15B Failure Modes and Effects Analysis (FMEA)

The information in this appendix of the reference ABWR DCD, including all subsections, tables, and figures, is incorporated by reference with the following departures.

STD DEP T1 3.4-1 (Table 15B-3)

STD DEP 7.7-1 (Figure 15B-1)

Figure 15B-1 Simplified CRD System Process Flow Diagram

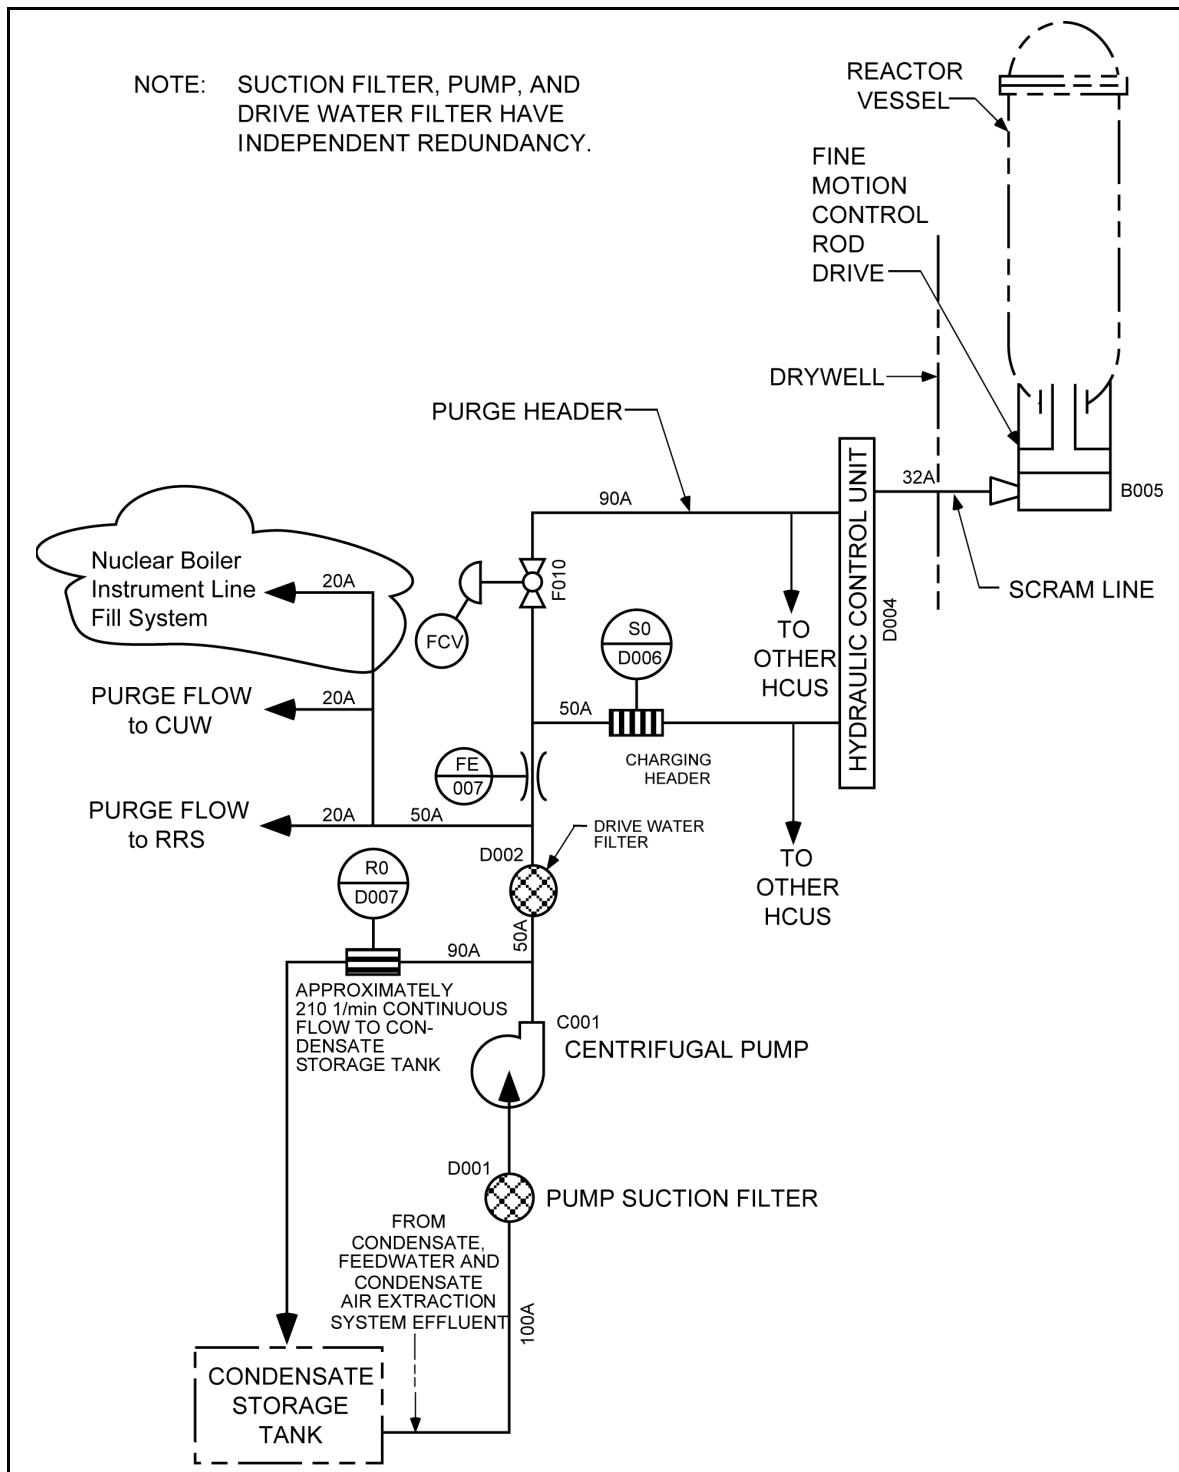
STD DEP 7.7-1

A simplified CRD System process flow diagram is shown in Figure 15B-1. CRD System water is taken from the condensate, feedwater and condensate air extraction system, or Condensate Storage Tank (CST) through a suction filter by a centrifugal pump and discharged through a drive water filter to the HCU. (During shutdown the CST is the primary source.) Each of these components is independently redundant and only one of each is in operation at any one time. A portion of the pump discharge flow is diverted through a minimum flow bypass line to the CST. The pumped water is directed to the HCU to provide hydraulic scram and to furnish purging to the drive. This system also provides purge water for the reactor internal pumps, nuclear boiler instrument lines, and the reactor water cleanup pumps.
